Permit Application Review

Permit No. 2020-17
Received complete: March 17, 2020

Applicant: Kit Bennett; Opus Development Co, LLC
Consultant: Pete Moreau; Sambatek, Inc.
Project: Golden Triangle Industrial
Location: Golden Triangle Drive and Valley View Road: Eden Prairie
Rule(s): 2, 3, 4, 5
Reviewer(s): BCO/LLH

SHEET NUMBER
C3.02

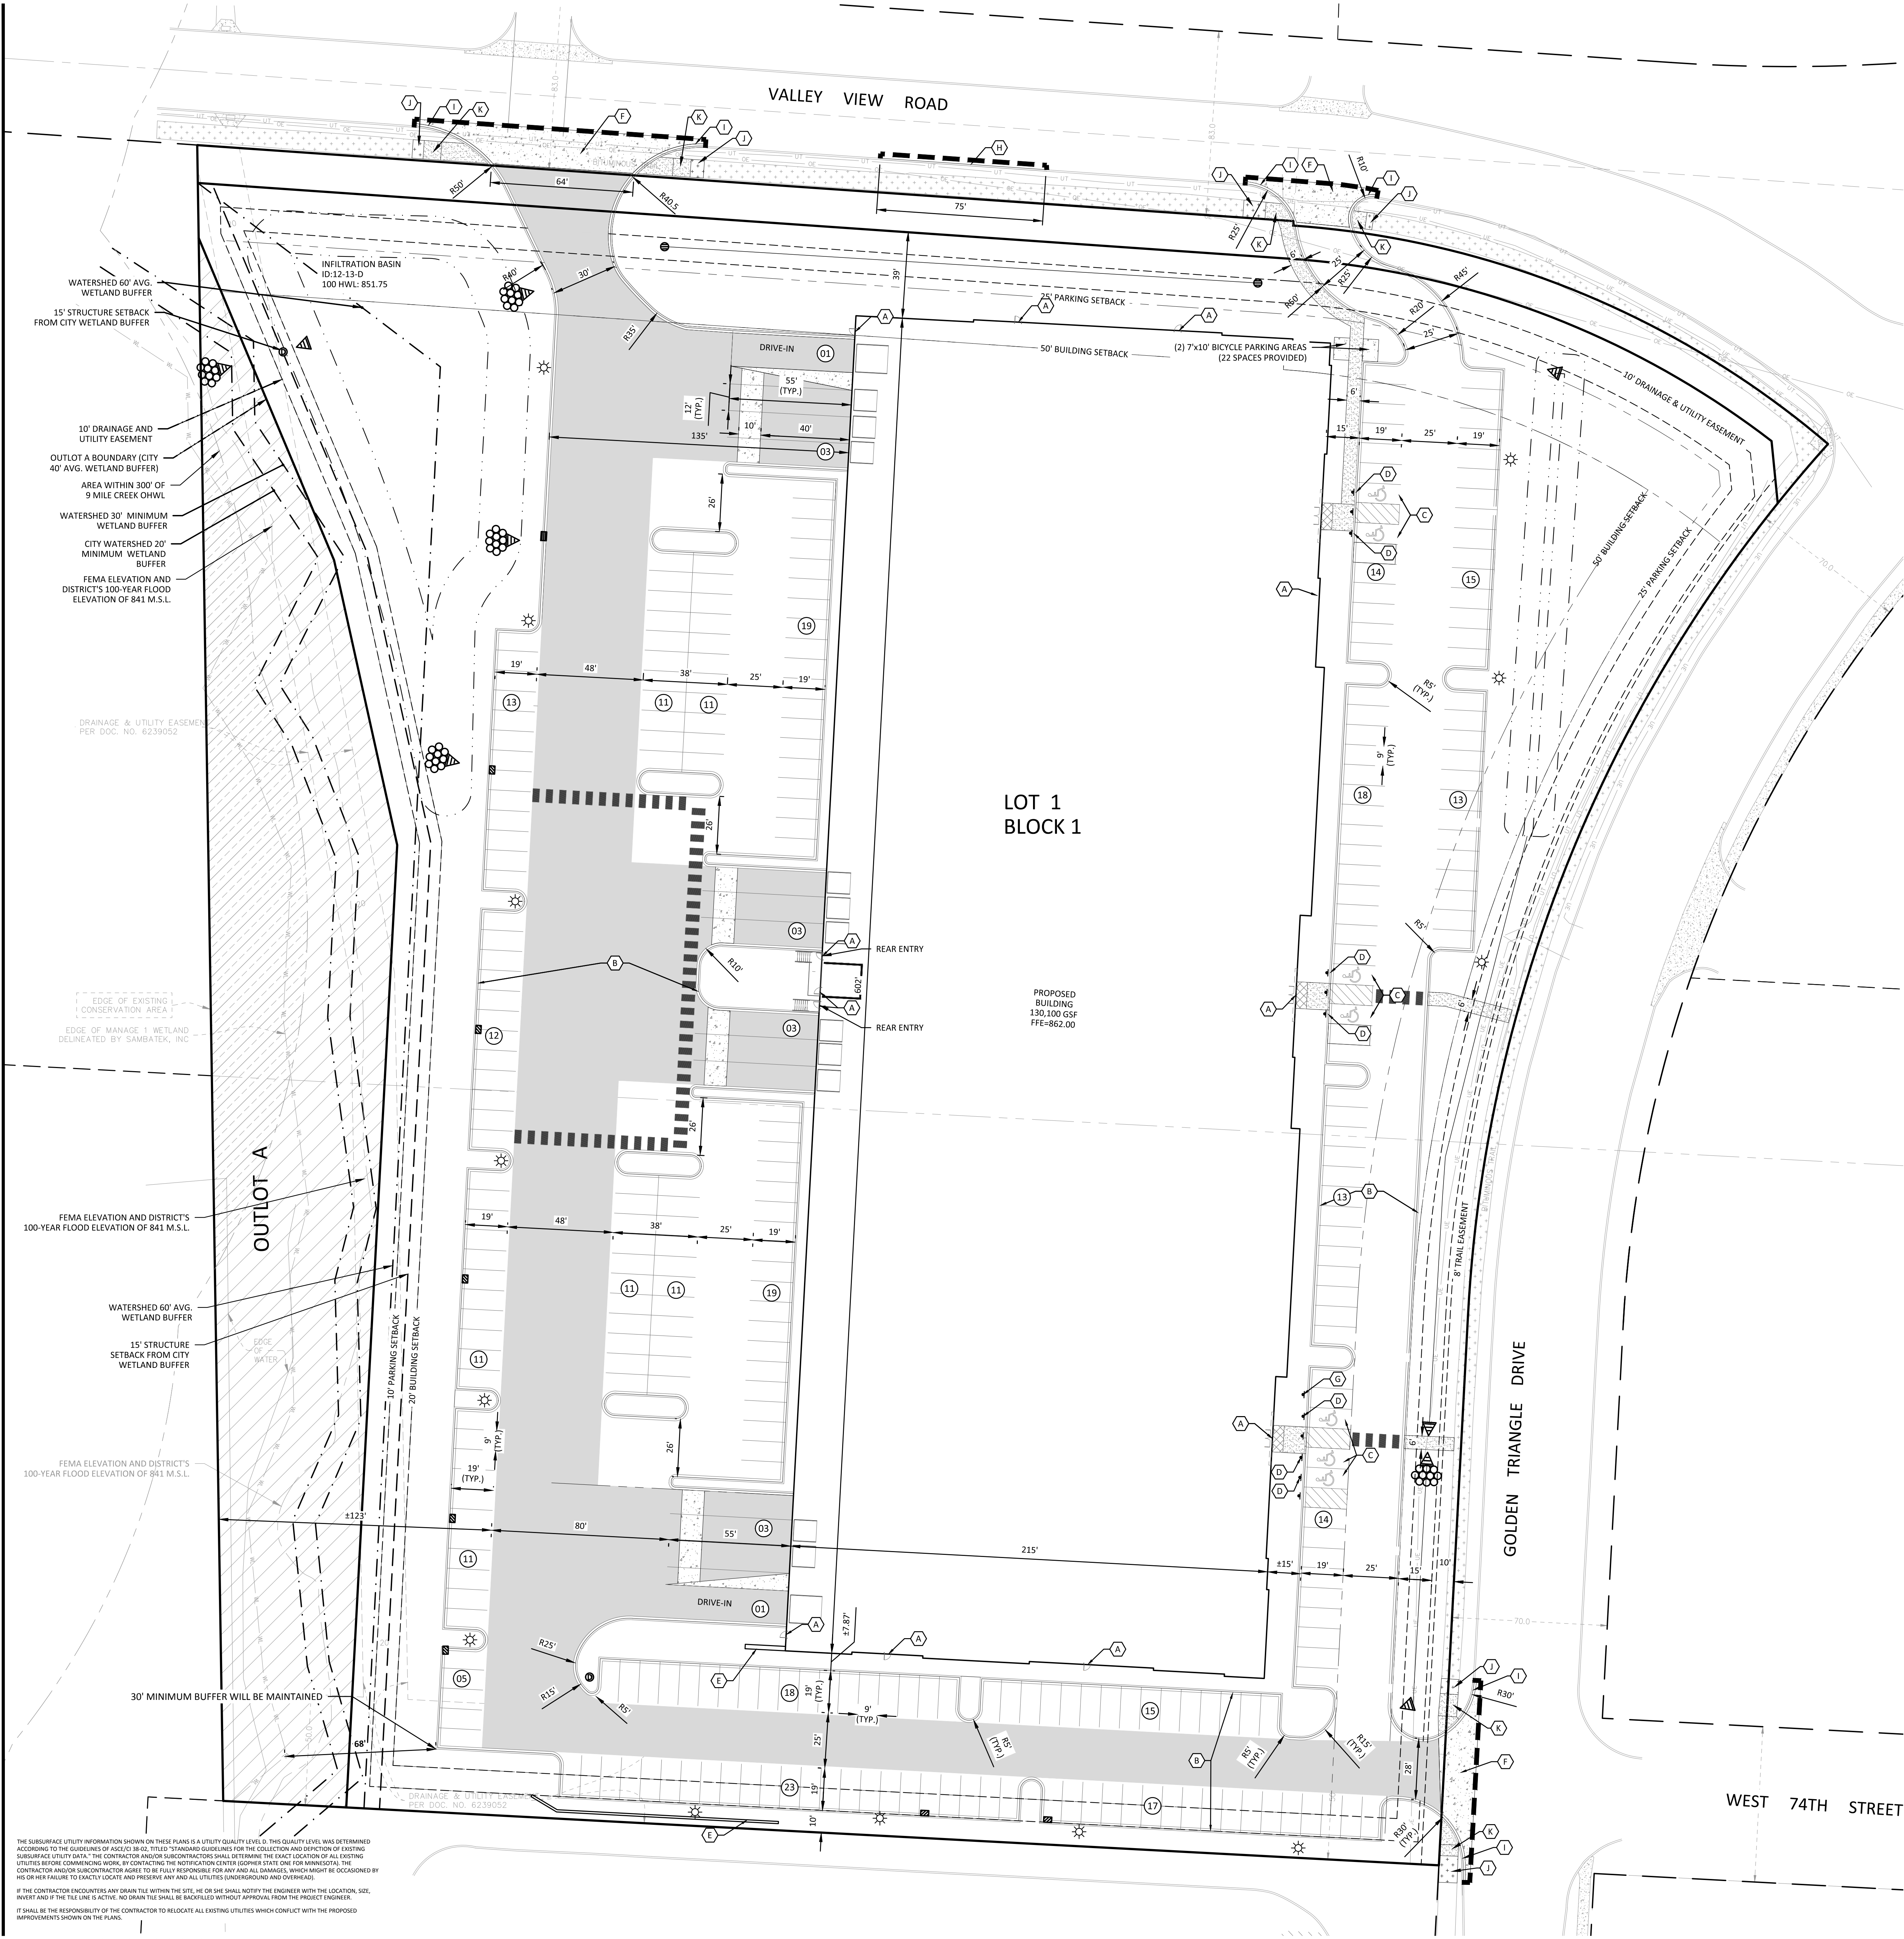
As identified in the site plans for the Baseline and Alternate Users (Sheets C3.01 and 3.02), an area of 43,721 square feet is required for the 60 foot average buffer. The site plans for both users show a buffer area of 44,581 square feet will be provided (Rule 3.4.1a). The plans are in conformance with the minimum buffer width required by District criteria.
